Mercedes-Benz

star bulletin

Date: December 6, 2007
 Order No.: P-B-13.22/01b
 Supersedes: P-B-13.22/01a dated Nov. 6, 2007
 Group: 13

**SUBJECT: All Passenger Models Equipped with Engine M272 or M273
 Whining / High Pitch Whistle Noise Coming From Front of Engine**

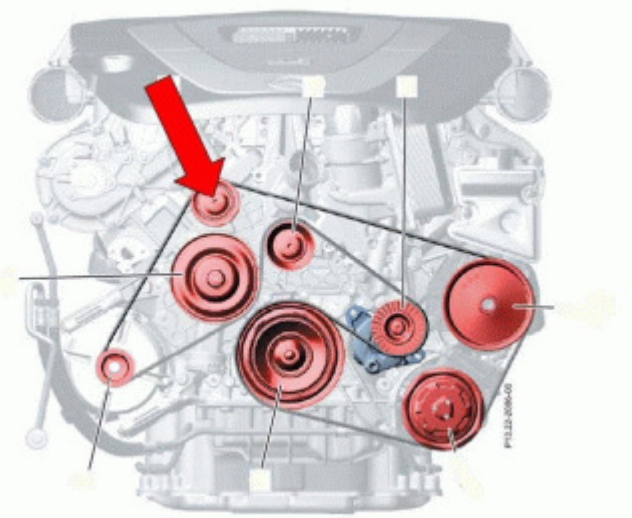
If you receive customer reports in the above model vehicles of a whining or high pitch whistle noise coming from the engine, this noise maybe caused by a faulty upper idler pulley. To resolve, replace the upper idler pulley with (Figure 1). The pulley is supplied as a package containing mounting bolt, dust cover and spacer. Fit the spacer between the case cover and guide pulley.

i Note: The new pulley comes packaged with a black plastic spacer which is used to hold the pulley assembly together. This bushing is to be removed and discarded before installation.
